RE: Submittal of Report for RCRA Facility  
Investigation  
TWC Permit for Industrial Solid Waste Management  
Site Number HW-50216  
EPA Hazardous Waste Permit Number TXD083570051

RE: RCRA Facility Investigation (RFI) Work Plan  
Review; Hazardous Waste Permit No. HW-50216;  
Industrial Solid Waste Registration No. 30614;  
EPA Registration No. TXD 083570051

**RESPONSES TO JULY 8, 1991 TWC COMMENTS  
RCRA FACILITY INVESTIGATION REPORT  
FMC CORPORATION  
PASADENA, TEXAS**

GROUNDWATER POTENTIOMETRIC  
SURFACE MAP OF POND AREA  
DATE MEASURE : 7-19-91  
EMC CORPORATION, BAYPORT PLANT  
PASADENA, TEXAS

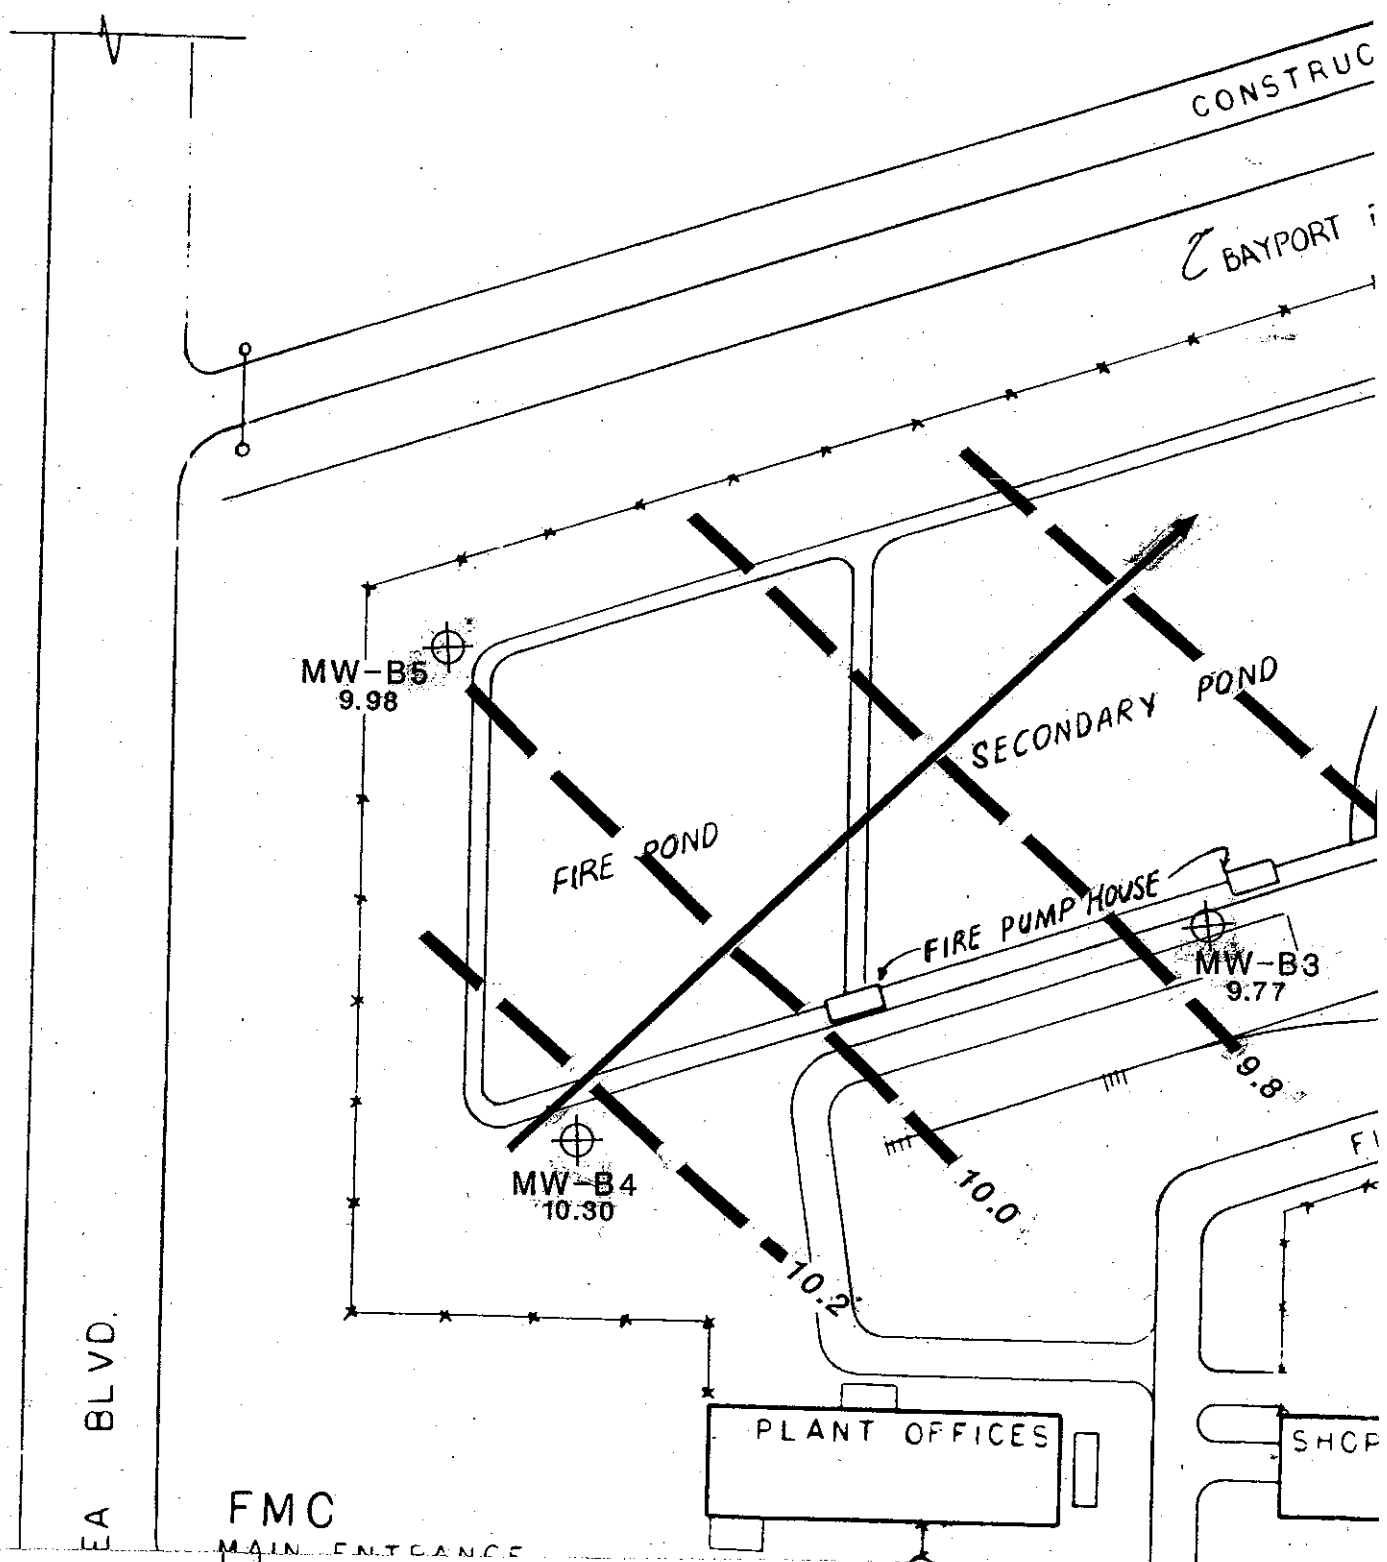
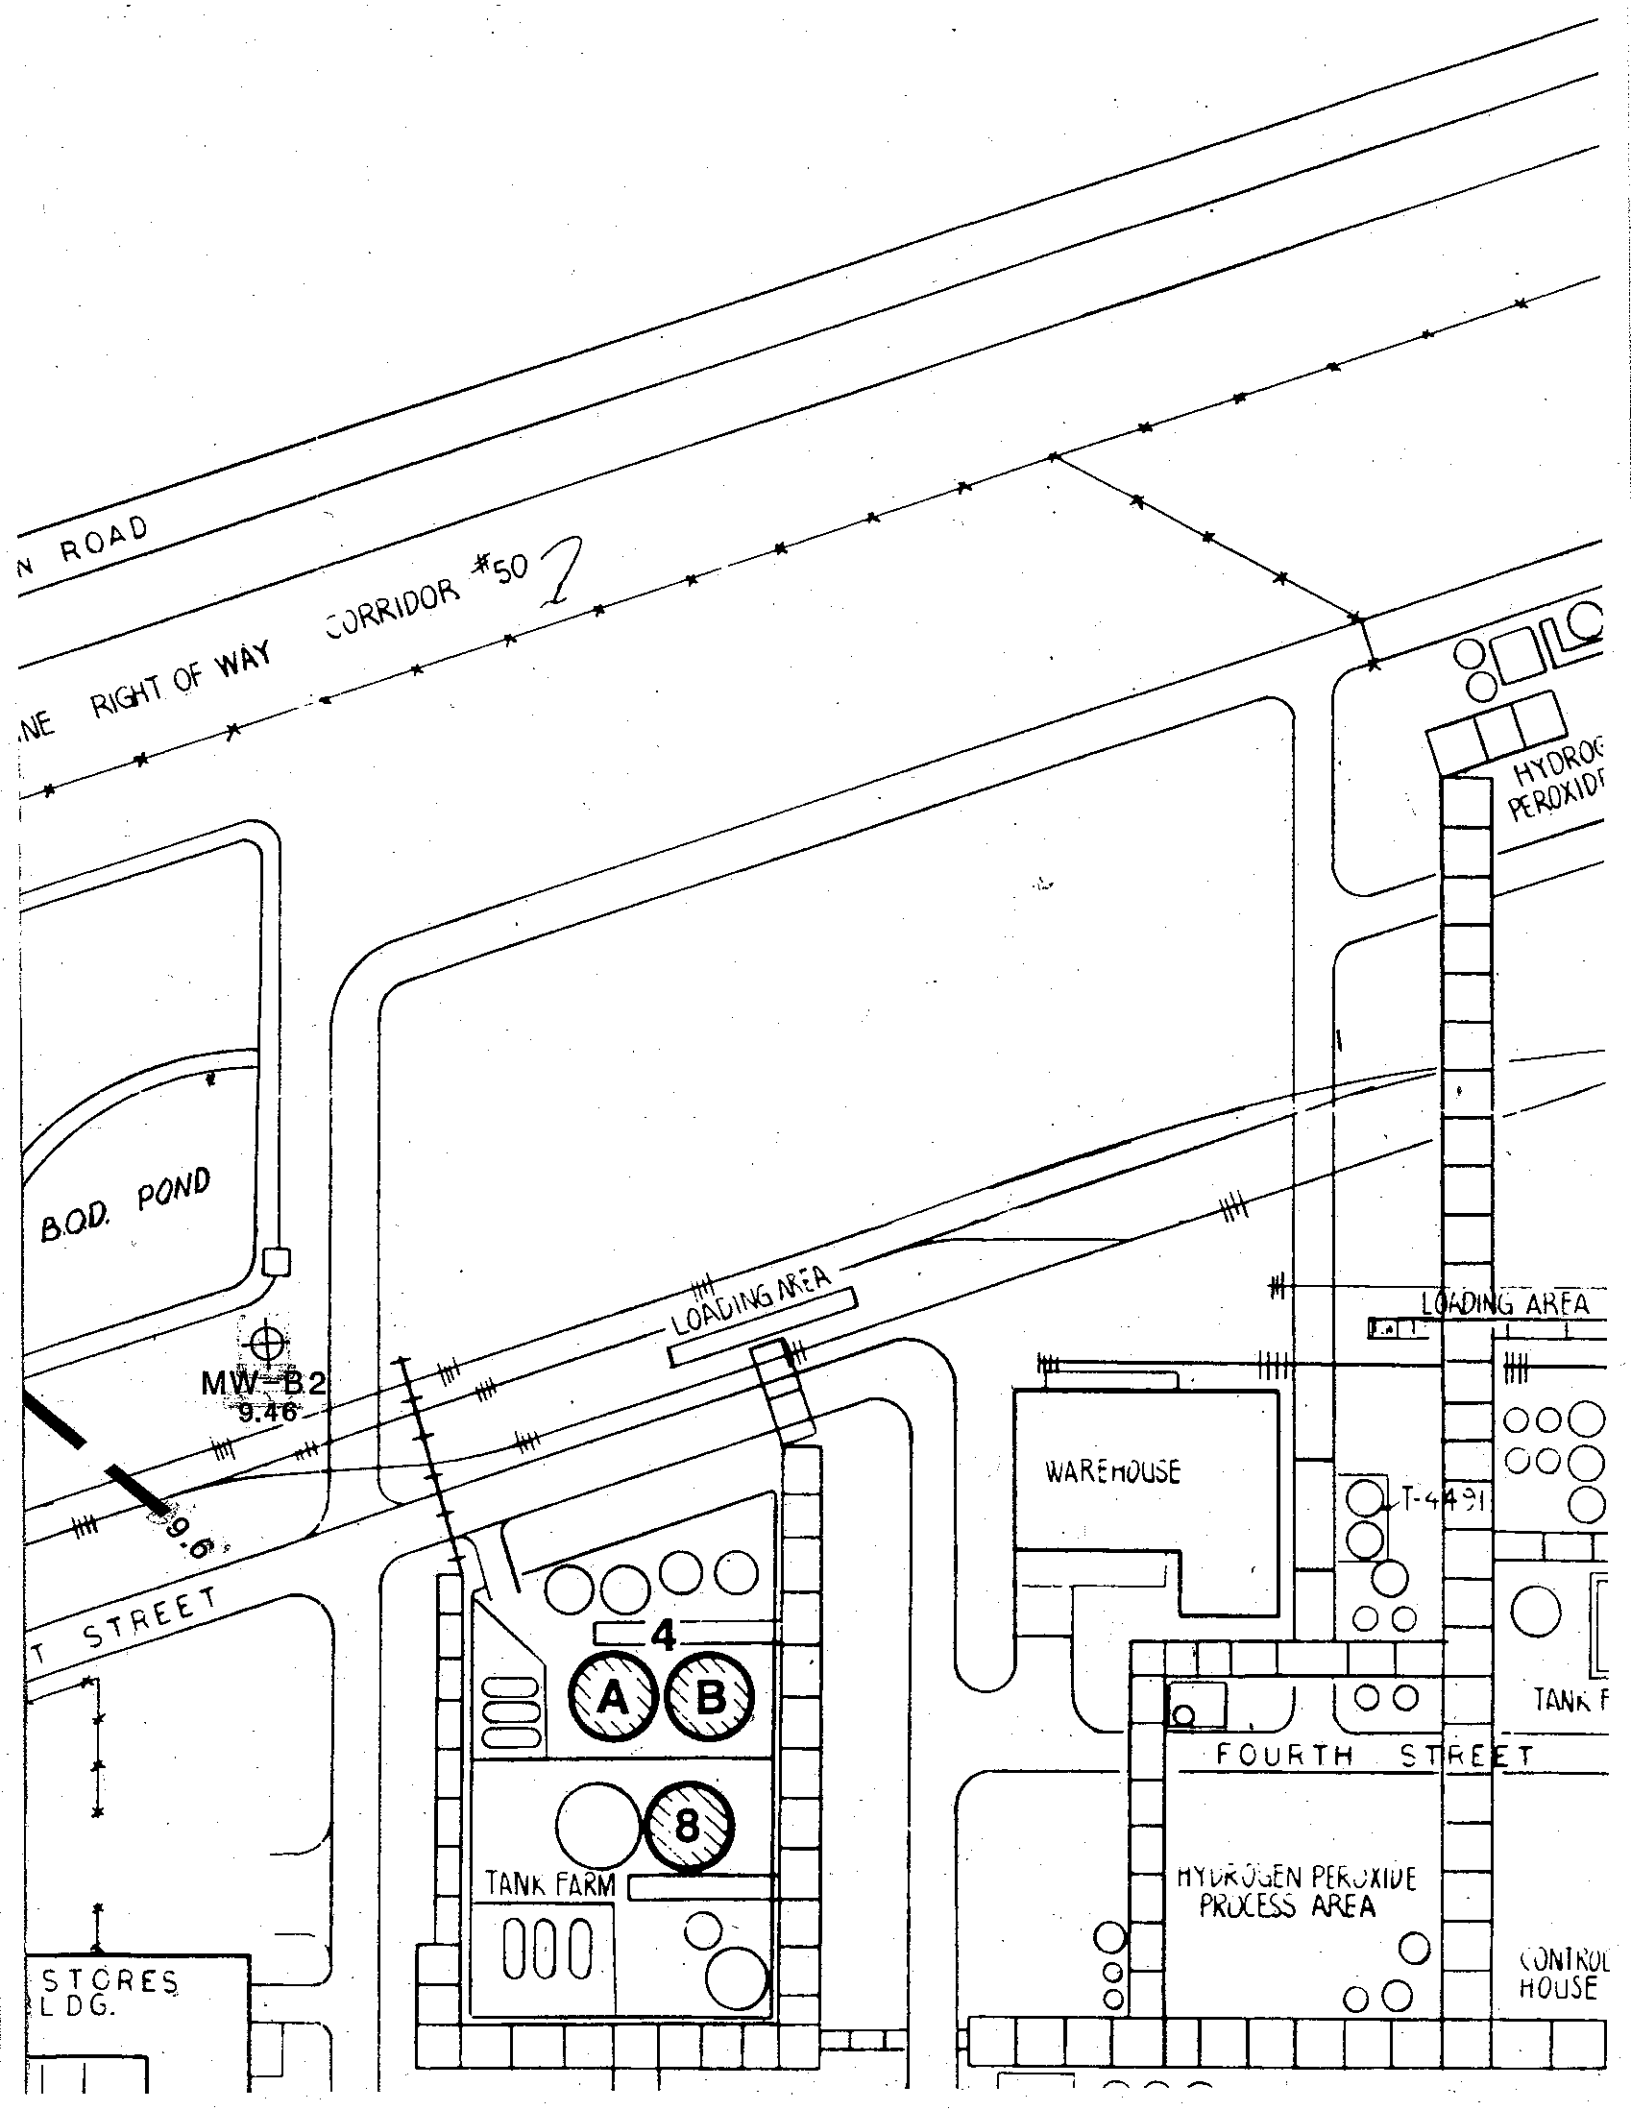
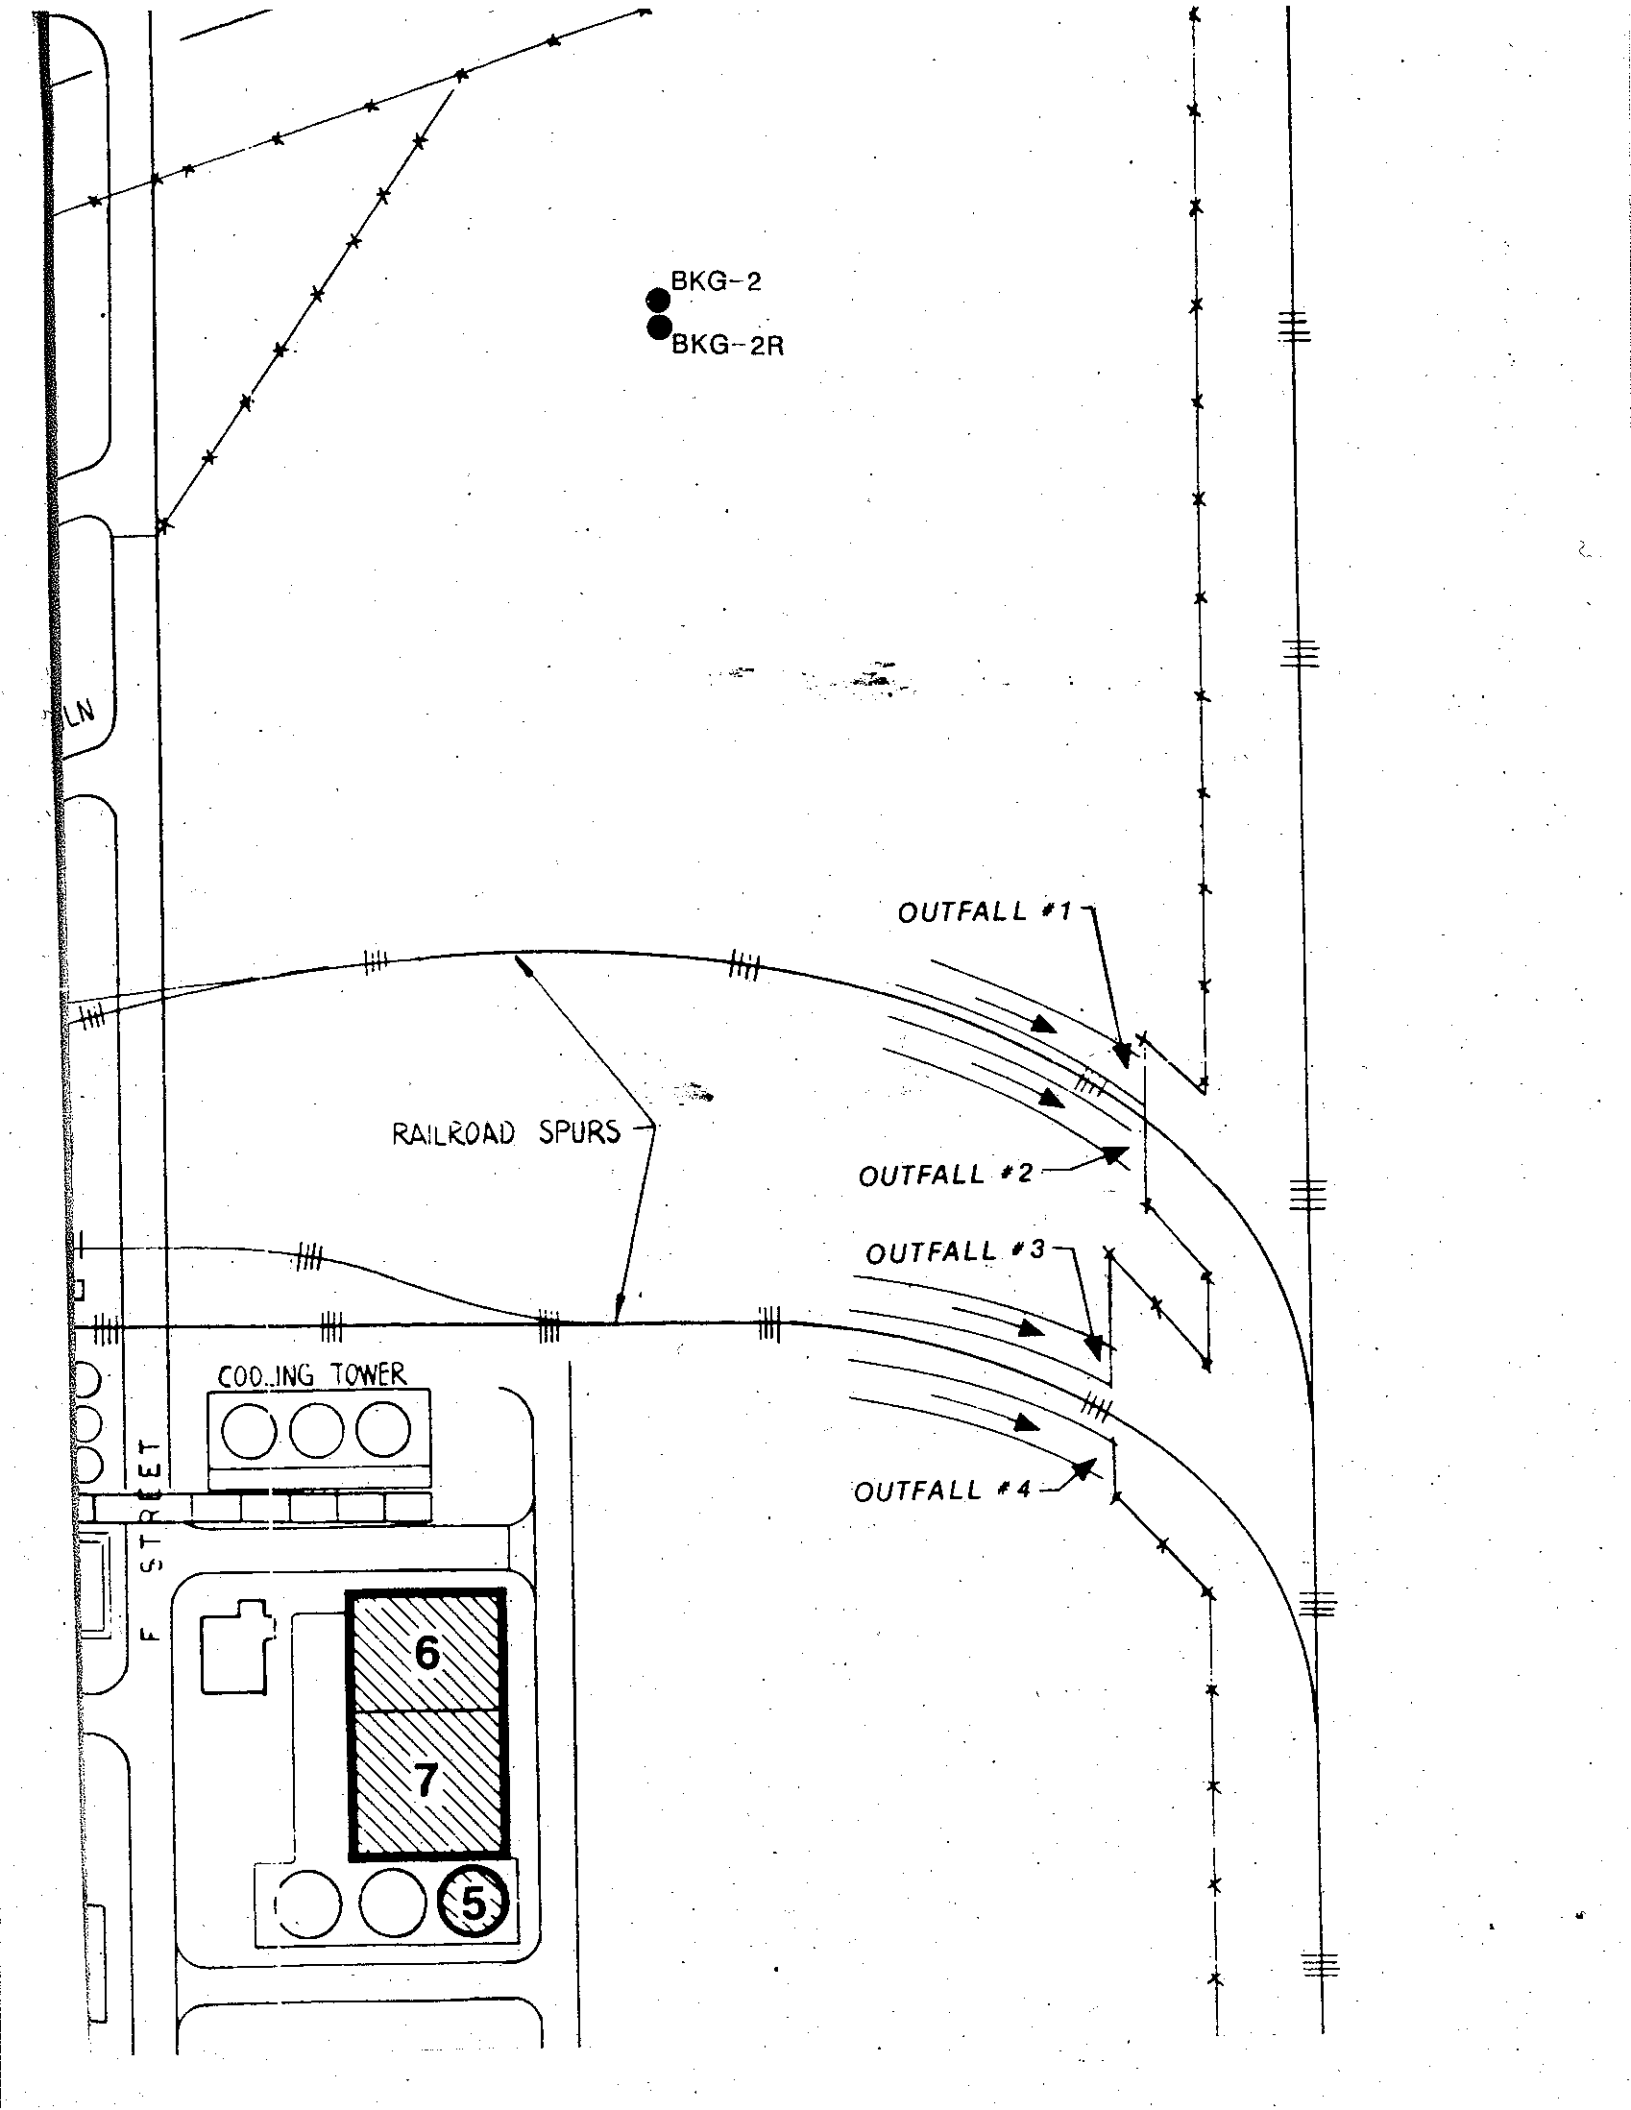
"Permit Provision VIII.A.2.b. is specific about characterizing encountered groundwater depth and movement. Your report suggests groundwater was encountered; however no specifics about inferred flow vector (i.e. velocity and direction) and encountered elevations were reported. Therefore, we require that you submit these data. Please be aware that the groundwater information for which we are asking is necessary for characterization purposes and should not be mistaken for the results of a groundwater study as specified in permit Provision VIII A.2.b.(2)."

The static water level measurements are presented below. Monitor well locations are shown on the attached map.

These water level measurements were used to calculate groundwater elevations and develop the attached potentiometric surface map. This map indicates that the direction of groundwater flow is northeast.
